MIL-M-28787/197A(SH)
AMENDMENT 3
24 August 1990
SUPERSEDING
AMENDMENT 2
18 February 1986

MODULES, STANDARD ELECTRONIC

INVERTER, DIGITAL, KEY CODE EBD

FIGURE 2. Operating temperature and life test circuit.

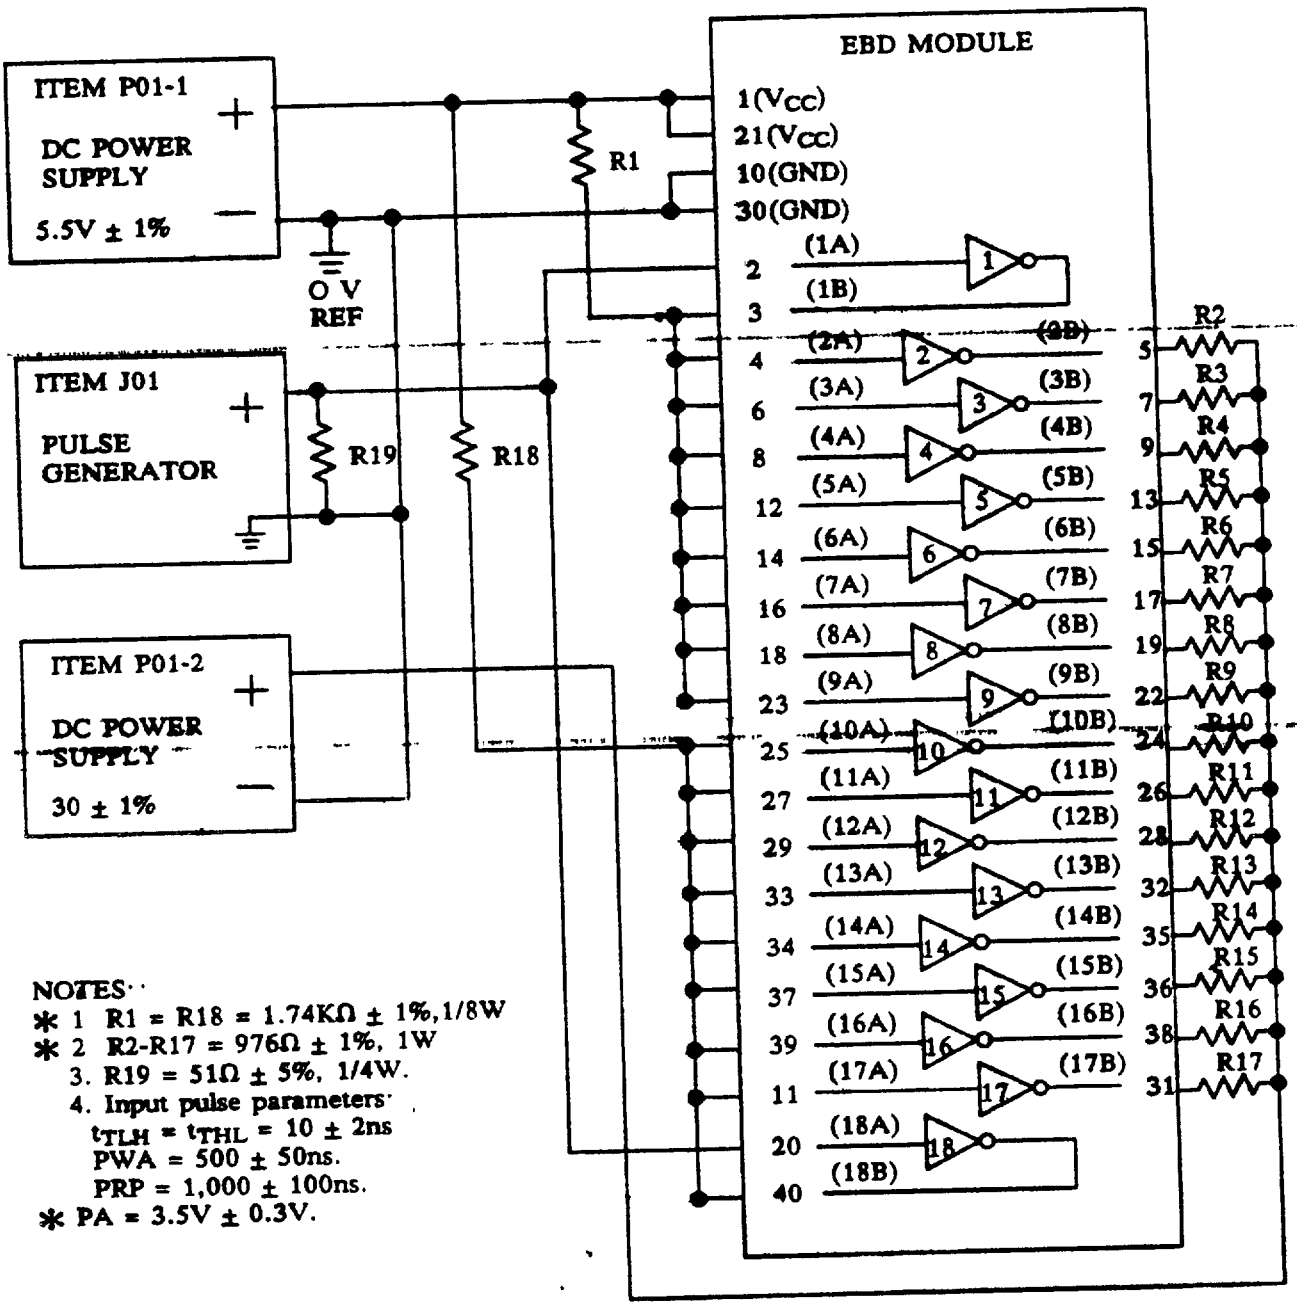
* FIGURE 2: Delete and substitute new figure 2 as printed on page 3 of this amendment

NOTES:
* 1 R1 = R18 = 1.74KΩ ± 1%,1/8W
* 2 R2-R17 = 976Ω ± 1%, 1W
3. R19 = 51Ω ± 5%, 1/4W.
4. Input pulse parameters:
$t_{TLH} = t_{THL}$ = 10 ± 2ns
PWA = 500 ± 50ns.
PRP = 1,000 ± 100ns.
* PA = 3.5V ± 0.3V.
